**OHIO RIVER BRIDGES  
SECTION 5 - EAST END BRIDGE  
VALUE ENGINEERING STUDY REPORT**

**Item Number 5-118.00**

**VALUE ENGINEERING STUDY  
for  
Kentucky Transportation Cabinet**

**Final Report**

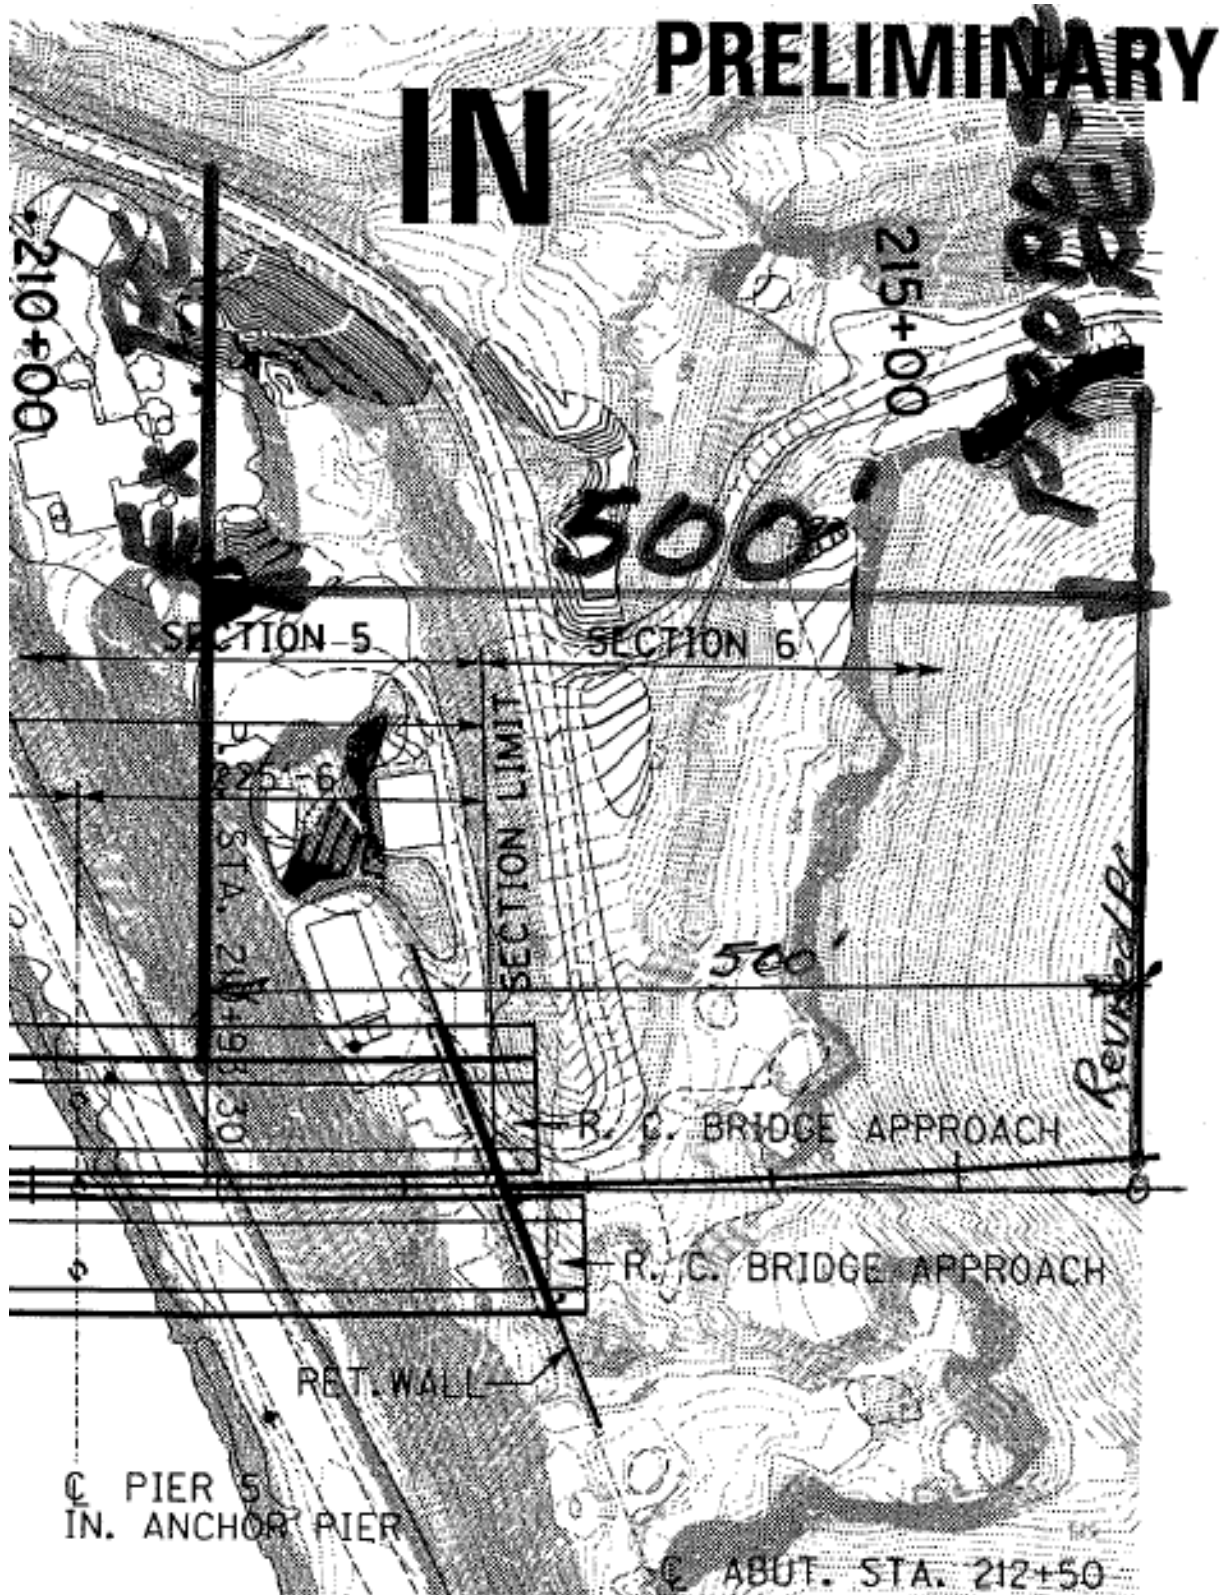
The plans, as currently designed, propose a horizontal curve with a radius of 5932.65 feet to the left.

It is proposed that the radius of the curve be decreased by a sufficient length to remove the curve from the bridge. If the PC of the curve, station 210+93.30 were to be moved 500 feet to the north, the transition from the tangent cross slope to the curve superelevation could be completely removed from the structure. The deflection angle for this curve is  $69.69^\circ$ , the tangent is 4130.51, and the radius is 5932.6 feet.

To move the PC 500 feet to the north would require the radius to be shortened to 5215 feet. With this curve, the external dimension of the curve would be reduced from 1296 feet to 1139 feet; therefore the midpoint of the curve would be shifted 157 feet to the northeast.
